ADDENDUM NO. ONE
NCSB -FBMS

To the Plans and Specifications for:
Nassau County School Board – Project No. 98110-031
Fernandina Beach Middle School Kitchen / Dining Remodeling and Campus
Renovations/Enhancements

Date: October 15, 2018

NEW SERVICE WALL ELEVATION (B)
SCALE: 1/2" = 1'-0"

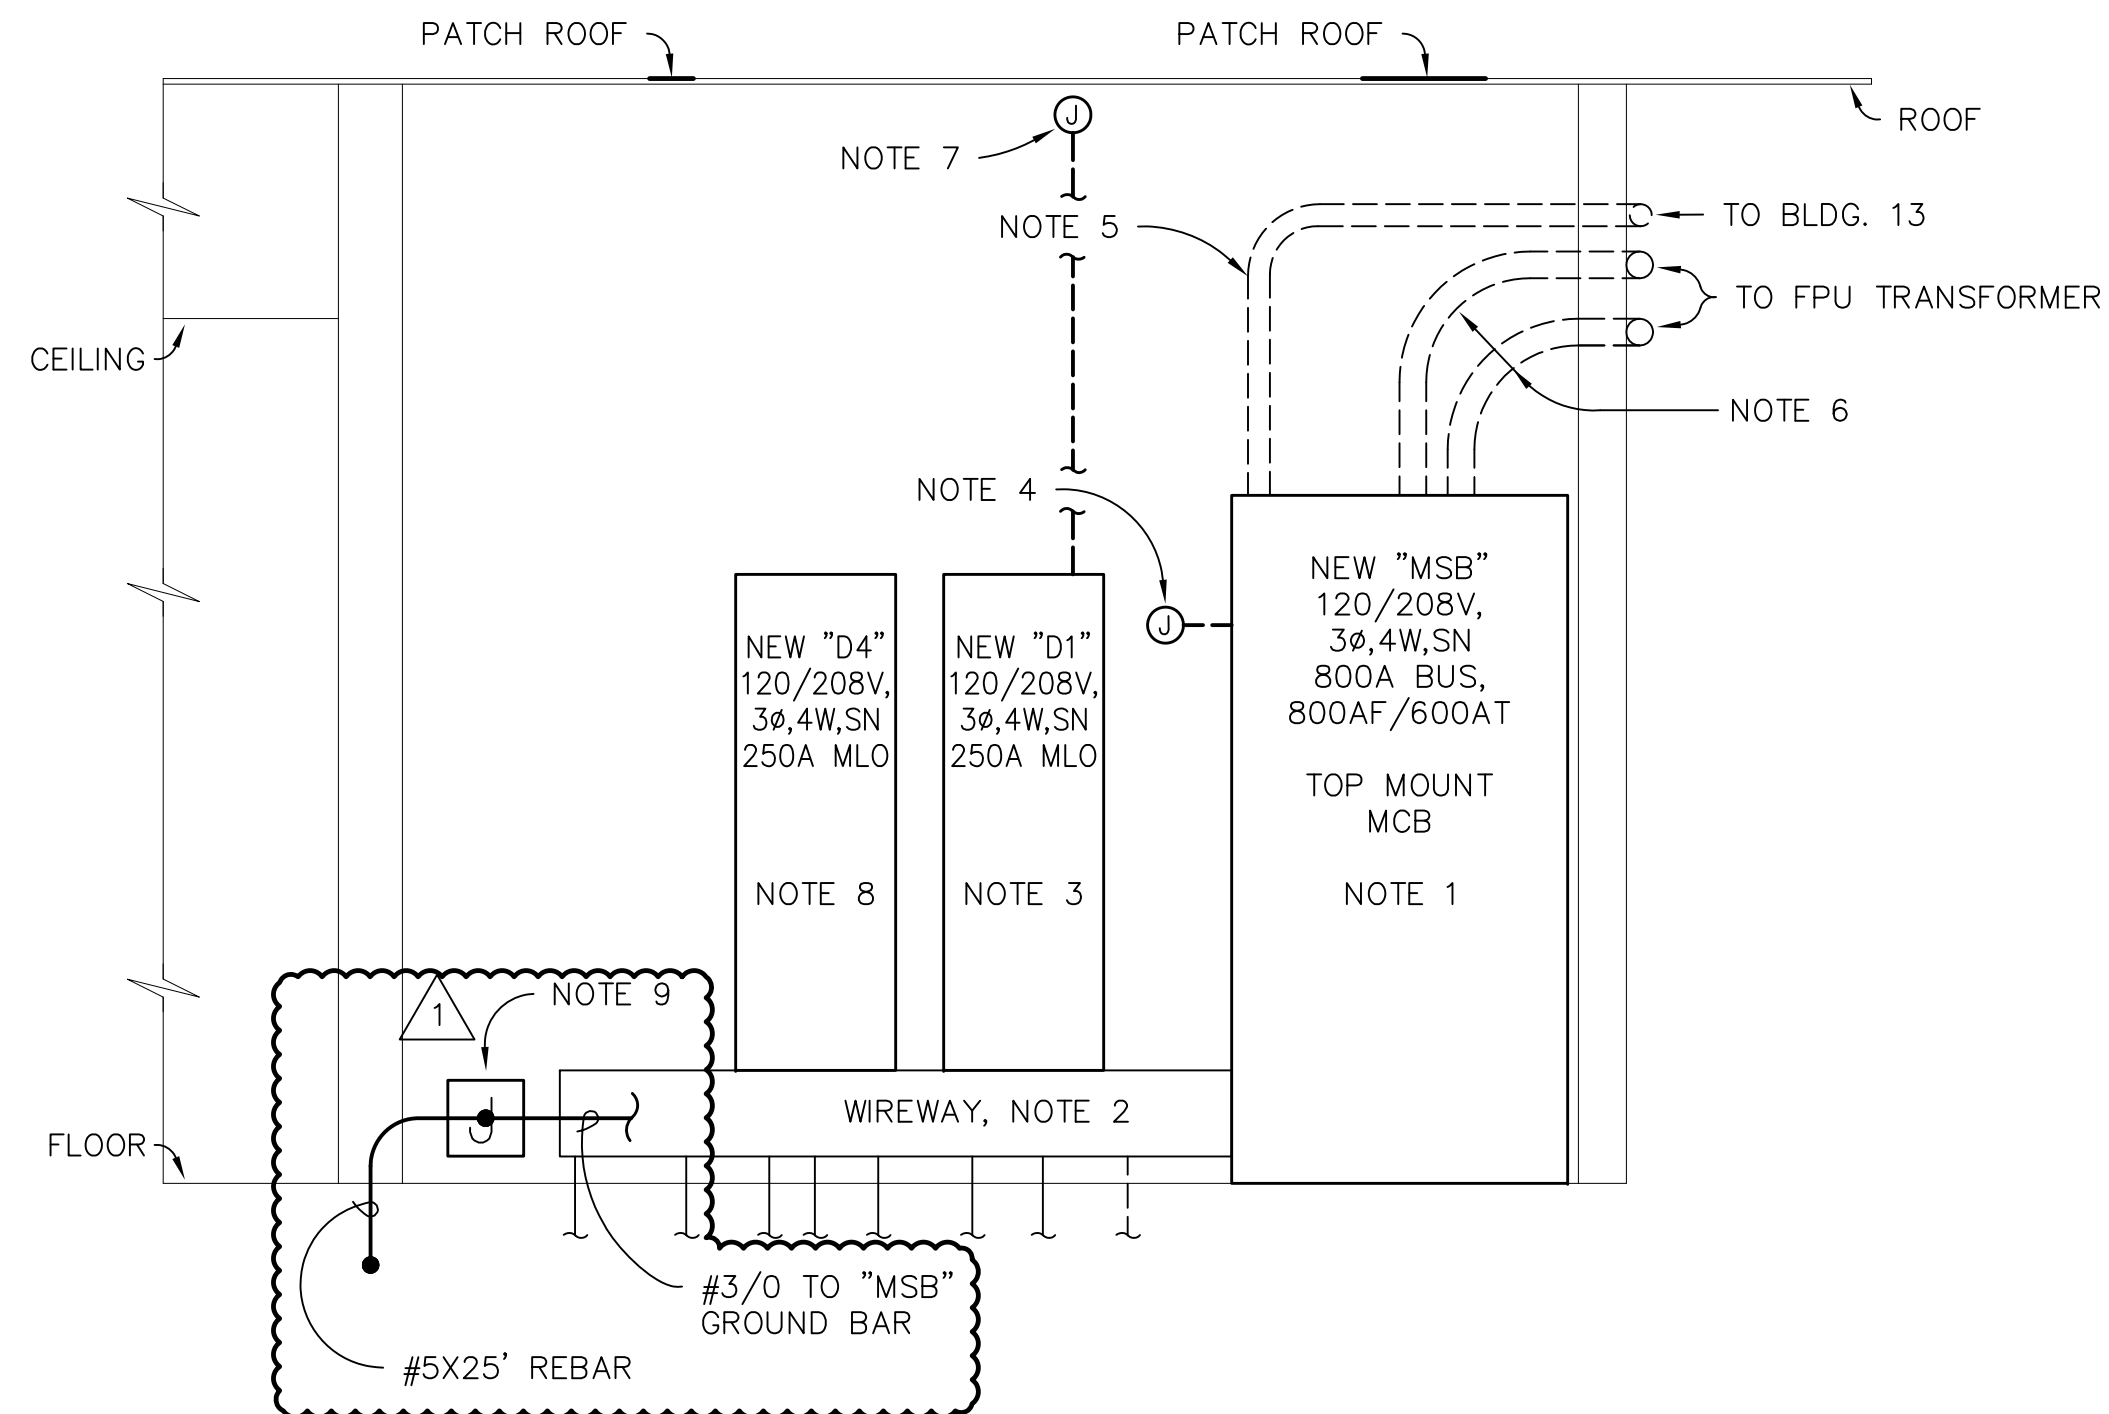
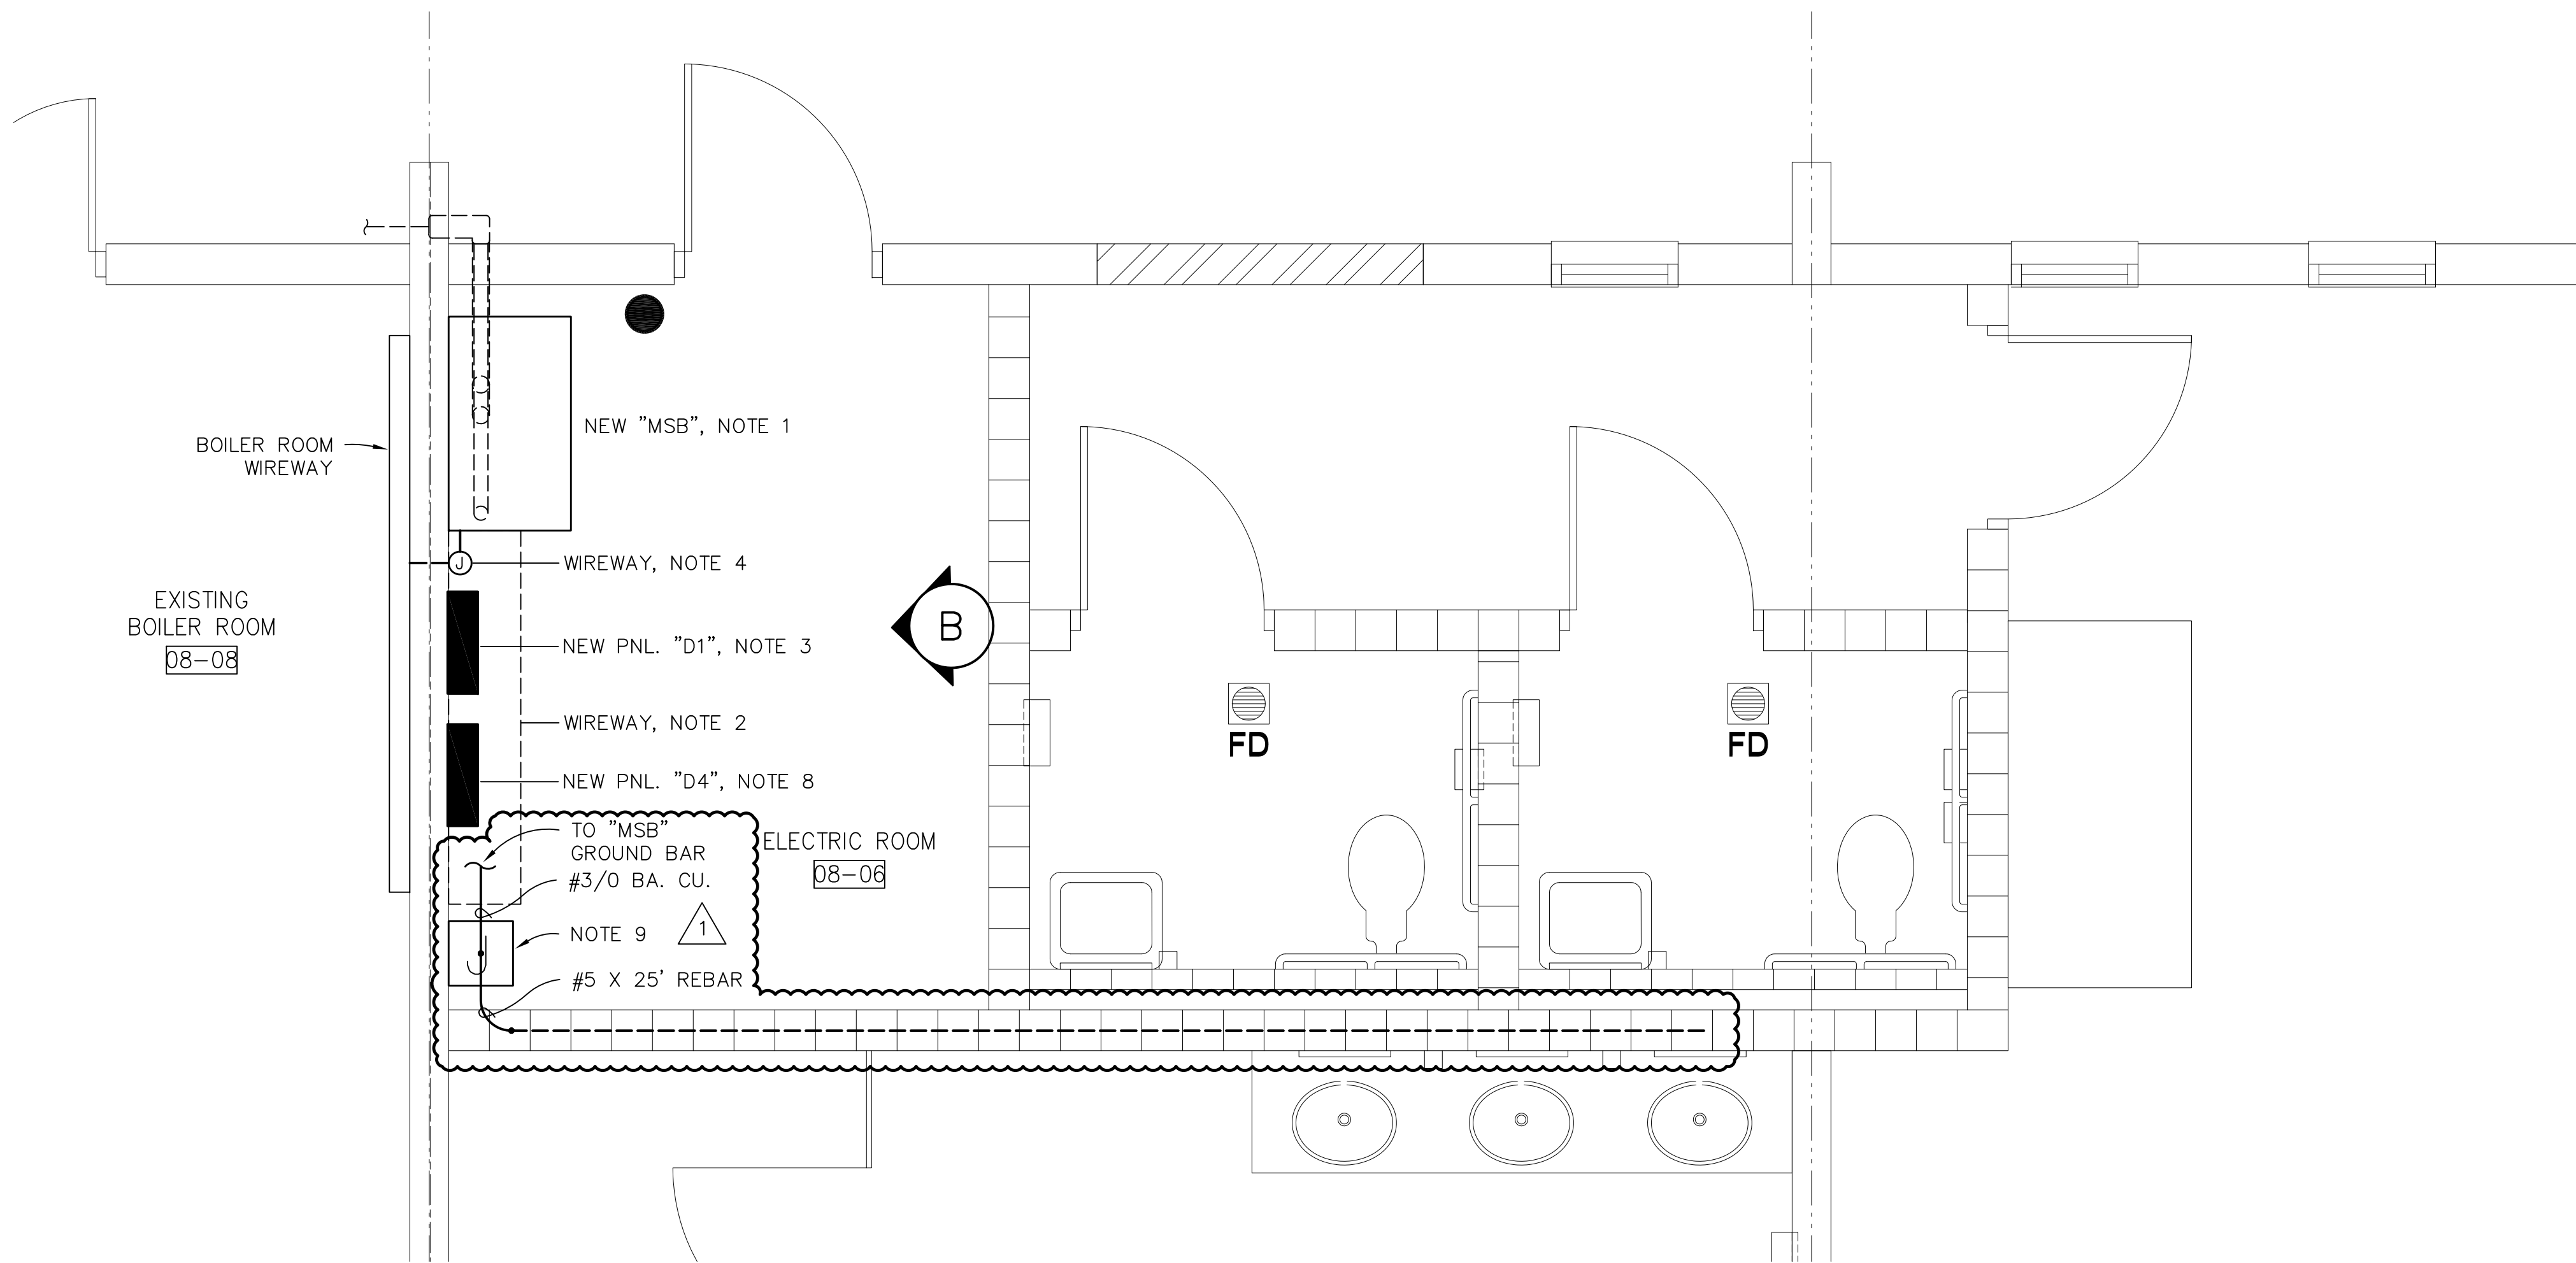
- a. Delete existing Drawing and insert attached new Drawing dated October 15, 2018.
- b. Add concrete encased rebar grounding at Electric room 08-011.
- c. See added Note 9.

9. PROVIDE A #5X25' REBAR ENCASED IN THE NEW WALL CONCRETE FOOTER AND ADJACENT TO FOOTER REBAR. PROVIDE EXOTHERMIC WELDED CONNECTION INSIDE JUNCTION BOX ON INTERIOR WALL. PROVIDE #3/0 BARE COPPER GROUND CONDUCTOR TO "MSB" GROUND BAR. SEE ADDITIONAL GROUNDING REQUIREMENTS ON DRAWING E-21.

BUILDING 08 LIGHTING PLAN	
DATE	9-25-2018
D.B.	LMC
C.B.	LMC
JOB NO.	18016

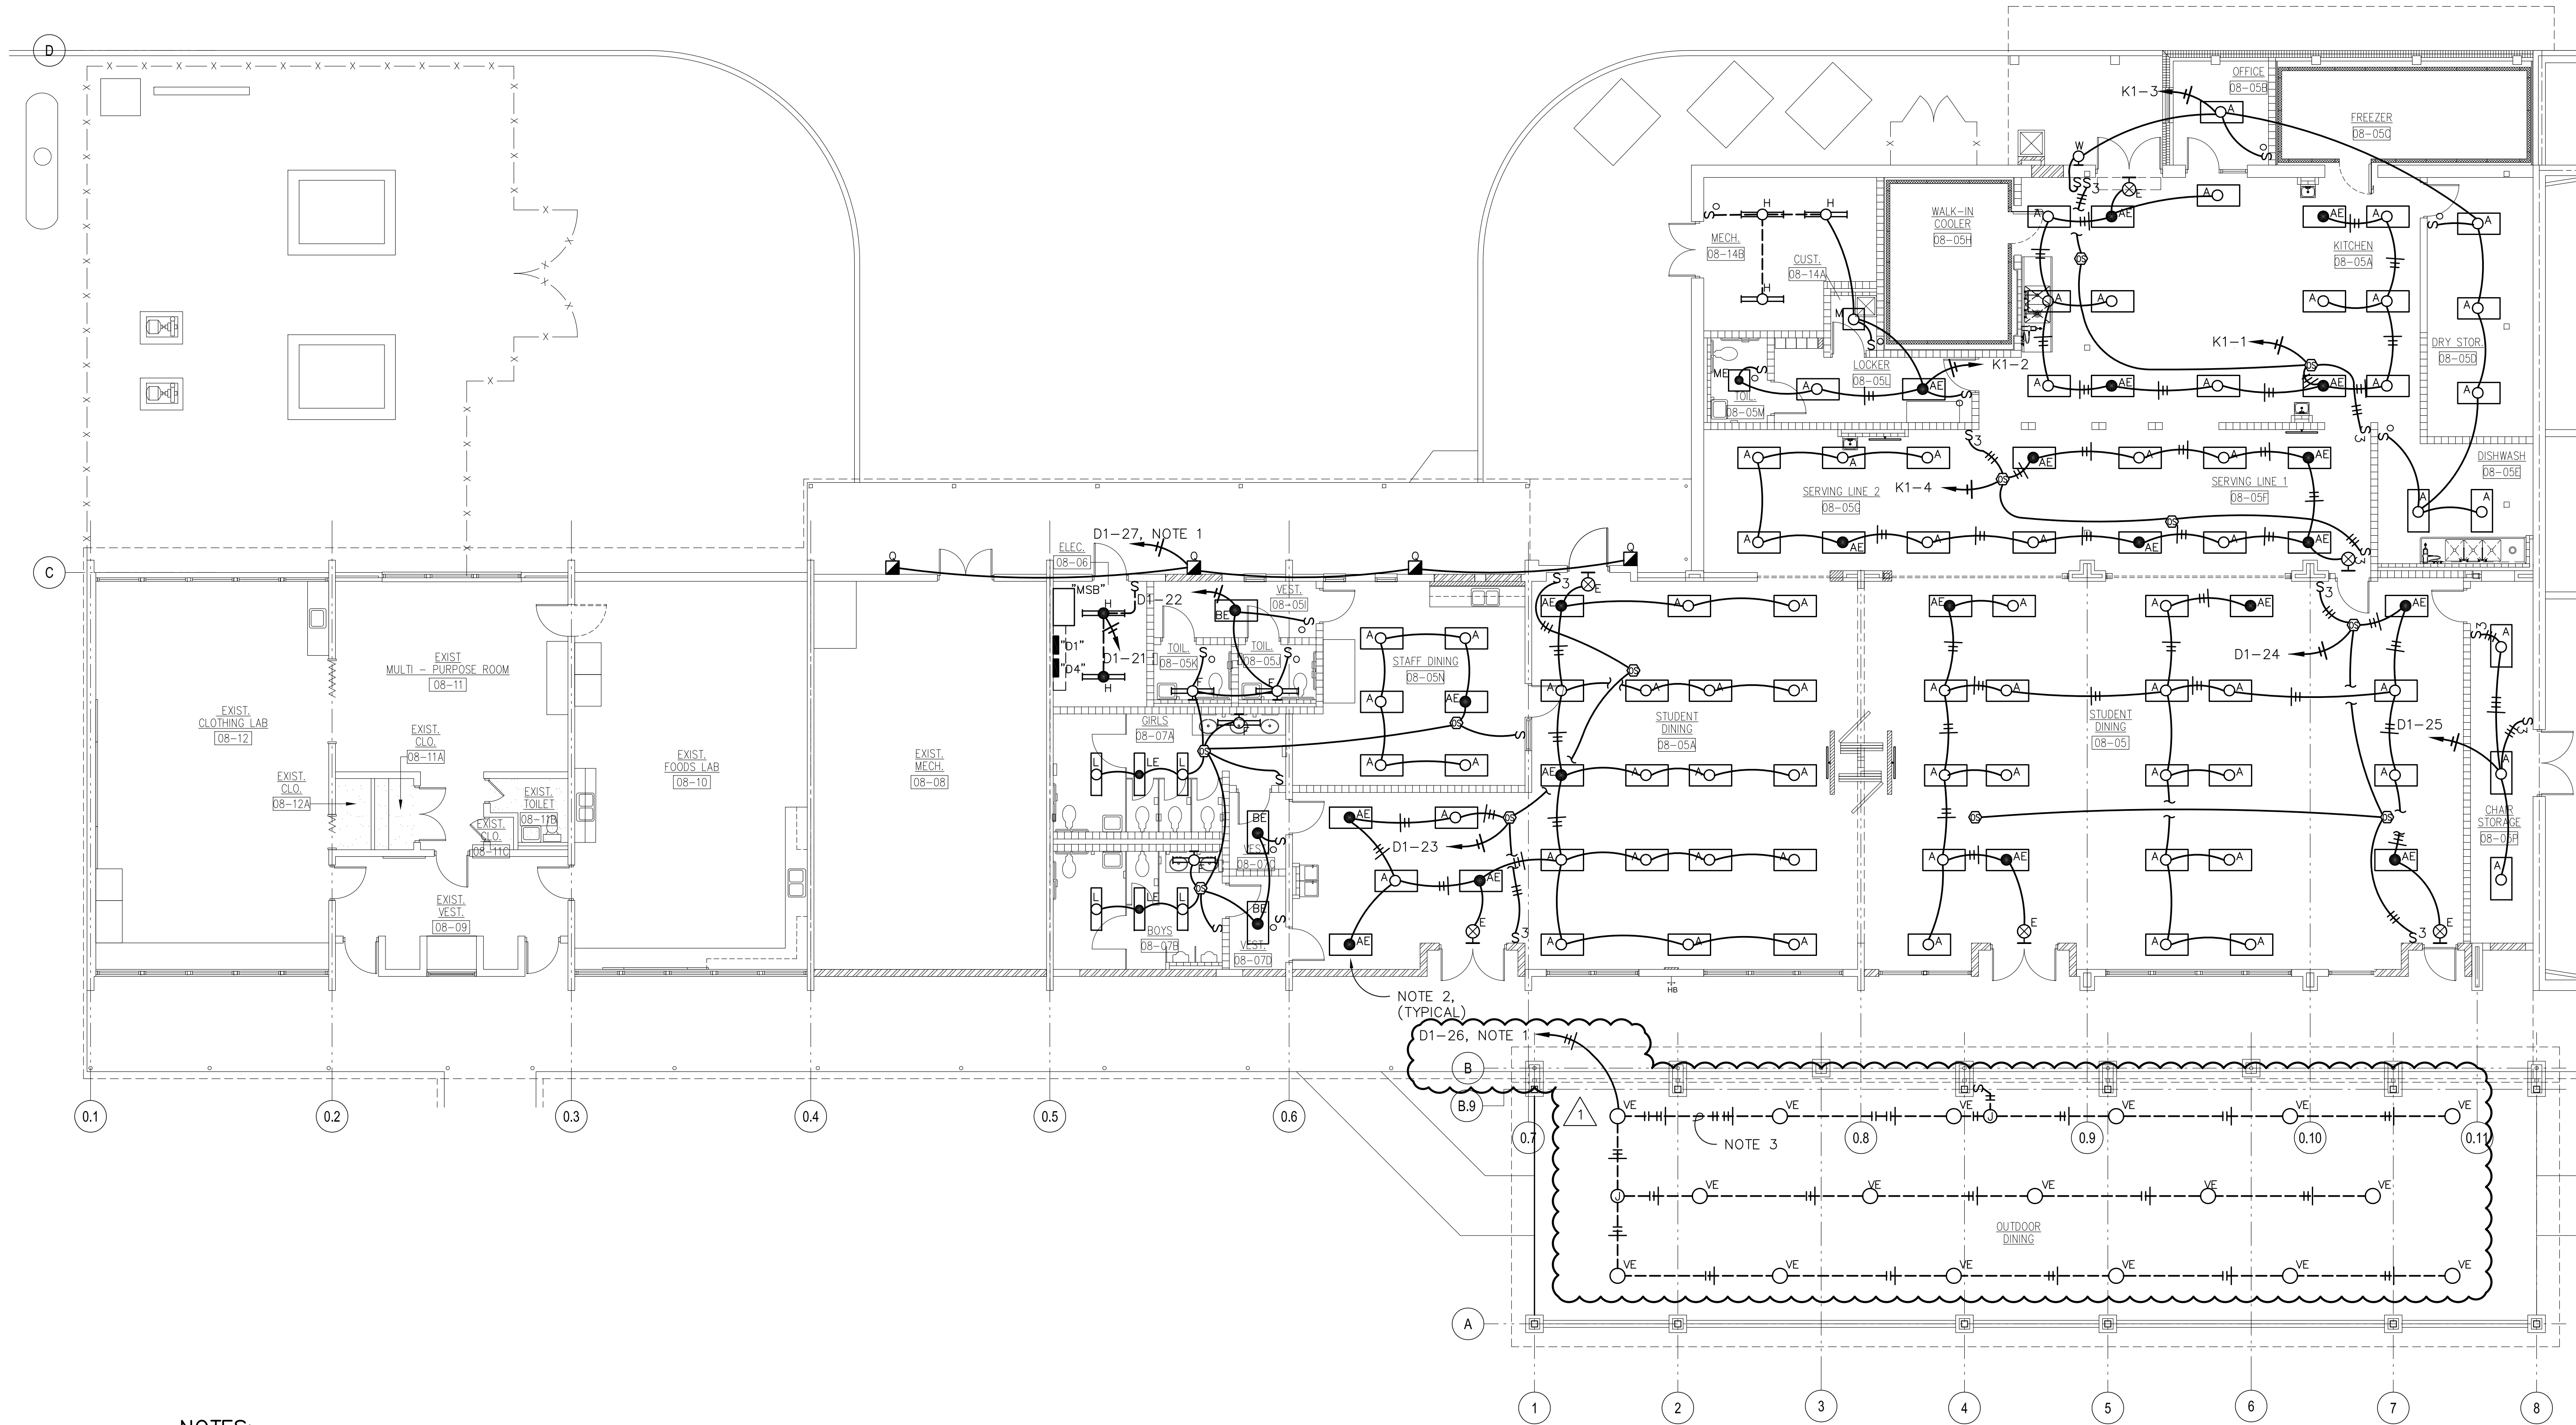
- a. Delete existing Drawing and insert attached new Drawing dated October 15, 2018.
- b. See revised lighting at Outdoor Dining.
